### **Recommendation to Hold a Public Hearing and Approve the North Pass Townhomes Subdivision Preliminary Plat**

**STAFF REPORT  
KETCHUM CITY COUNCIL  
REGULAR MEETING OF AUGUST 17<sup>th</sup>**

**PROJECT:** North Pass No. 8 Townhouse Subdivision Preliminary Plat

**FILE NUMBER:** P20-041

Exhibit A:  
Preliminary Plat

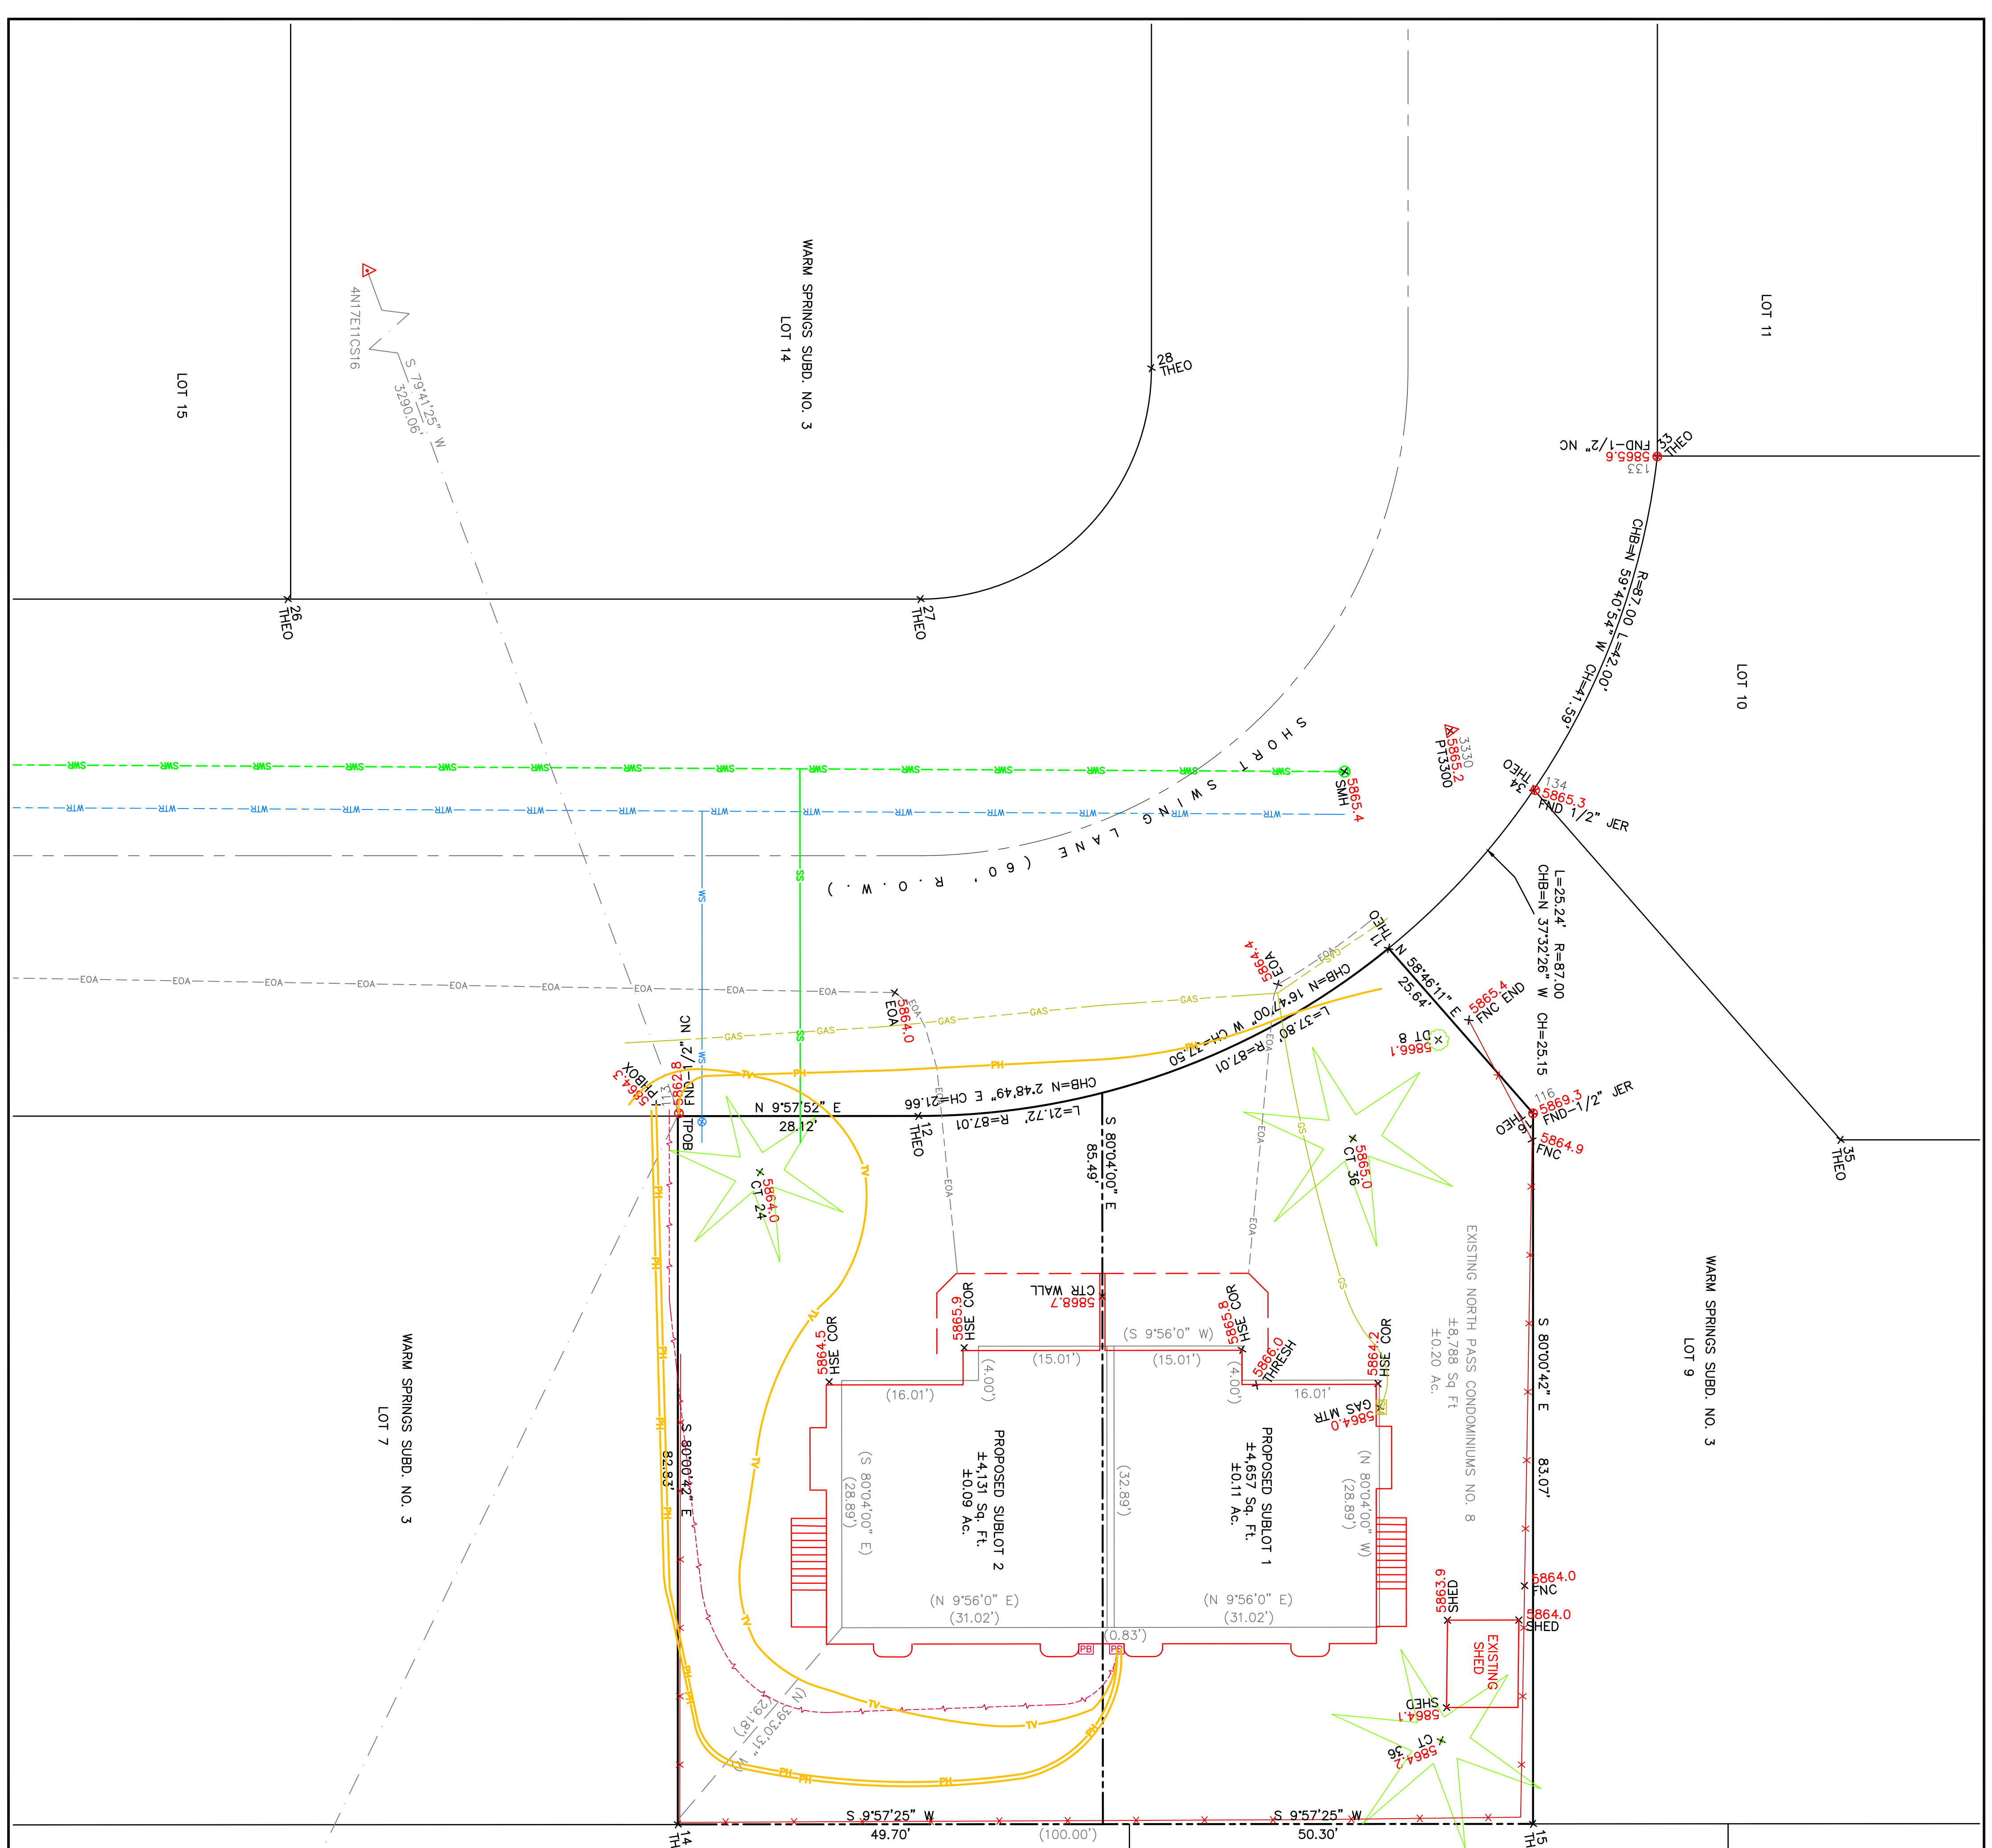
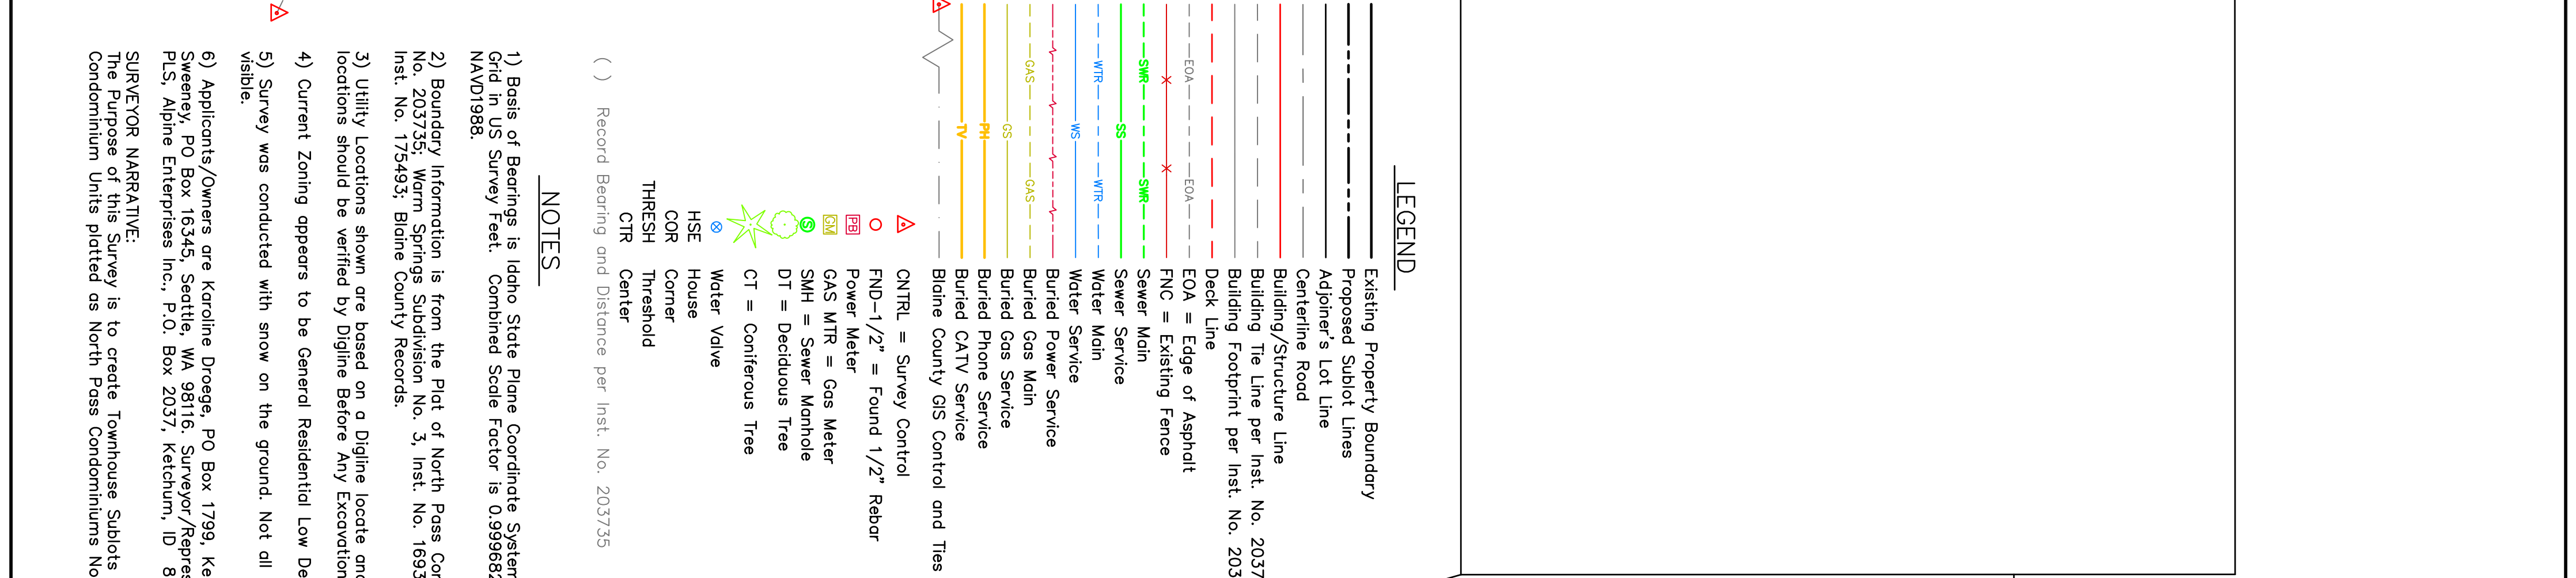
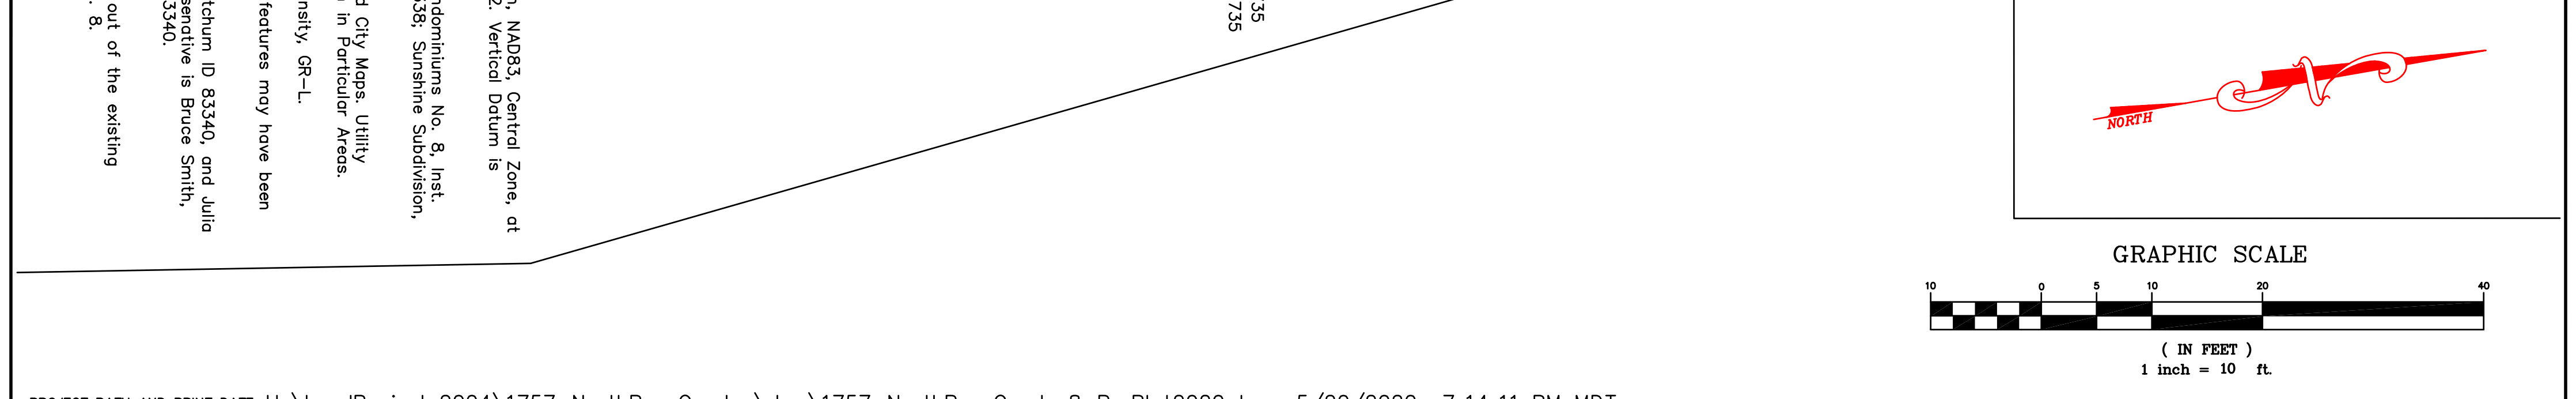
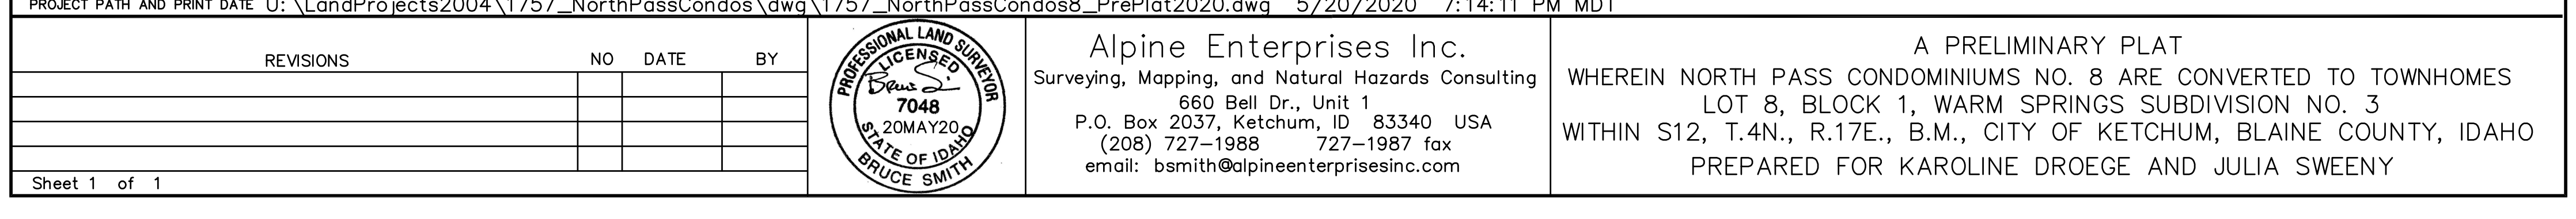
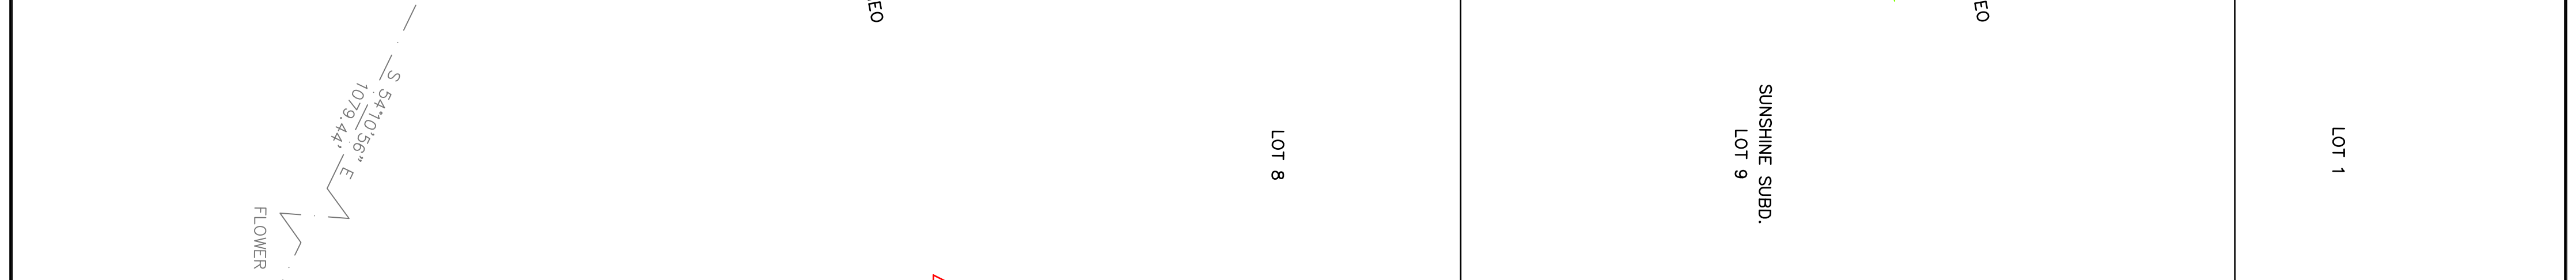
<b>Findings</b>	<i>The property is within the GR-L Zoning District. Plat note #4 references the zoning district.</i>
<input checked="" type="checkbox"/>	<input type="checkbox"/>	<input type="checkbox"/>	<b>16.04.030.J.10</b>	<b>The proposed location of street rights of way, lots, and lot lines, easements, including all approximate dimensions, and including all proposed lot and block numbering and proposed street names.</b>
			<b>Findings</b>	<i>This standard has been met. No new streets are proposed. The subplot lines and dimensions are indicated on the preliminary plat.</i>
<input checked="" type="checkbox"/>	<input type="checkbox"/>	<input type="checkbox"/>	<b>16.04.030.J.11</b>	<b>The location, approximate size and proposed use of all land intended to be dedicated for public use or for common use of all future property owners within the proposed subdivision.</b>
			<b>Findings</b>	<i>No land for common or public use is required or proposed.</i>

<b>Findings</b>	<i>The mature trees indicated on the preliminary plat shall be preserved.</i>
<input type="checkbox"/>	<input type="checkbox"/>	<input checked="" type="checkbox"/>	<b>16.04.040.B</b>	<b>Improvement Plans:</b> Prior to approval of final plat by the commission, the subdivider shall file two (2) copies with the city engineer, and the city engineer shall approve construction plans for all improvements required in the proposed subdivision. Such plans shall be prepared by a civil engineer licensed in the state.
			<b>Findings</b>	<i>N/A as no new improvements are proposed with this townhouse subdivision.</i>
<input type="checkbox"/>	<input type="checkbox"/>	<input checked="" type="checkbox"/>	<b>16.04.040.C</b>	<b>Prior to final plat approval, the subdivider shall have previously constructed all required improvements and secured a certificate of completion from the city engineer. However, in cases where the required improvements cannot be constructed due to weather conditions or other factors beyond the control of the subdivider, the city council may accept, in lieu of any or all of the required improvements, a performance bond filed with the city clerk to ensure actual construction of the required improvements as submitted and approved. Such performance bond shall be issued in an amount not less than one hundred fifty percent (150%) of the estimated costs of improvements as determined by the city engineer. In the event the improvements are not constructed within the time allowed by the city council (which shall be one year or less, depending upon the individual circumstances), the council may order the improvements installed at the expense of the subdivider and the surety. In the event the cost of installing the required improvements exceeds the amount of the bond, the subdivider shall be liable to the city for additional costs. The amount that the cost of installing the required improvements exceeds the amount of the performance bond shall automatically become a lien upon any and all property within the subdivision owned by the owner and/or subdivider.</b>

<b>Findings</b>	<i>The existing mature trees indicated on the preliminary plat shall be preserved.</i>

8. Prior to the City Clerk's signature of final plat, smoke and carbon monoxide detectors shall be installed to meet current building code.
9. The following plat note shall be added to the plat prior to forwarding the Final Plat application to City Council for review:

*This duplex was constructed in 1979 and converted to a townhouse pursuant to Ketchum Municipal Code §16.04.070. The duplex is not in compliance with section R302.2 of the current International Residential Code and the City's local amendments to the building code specified in Ketchum Municipal Code §15.04.020, which require a 2-hour fire-resistant wall assembly separation, in effect at the date of this plat.*
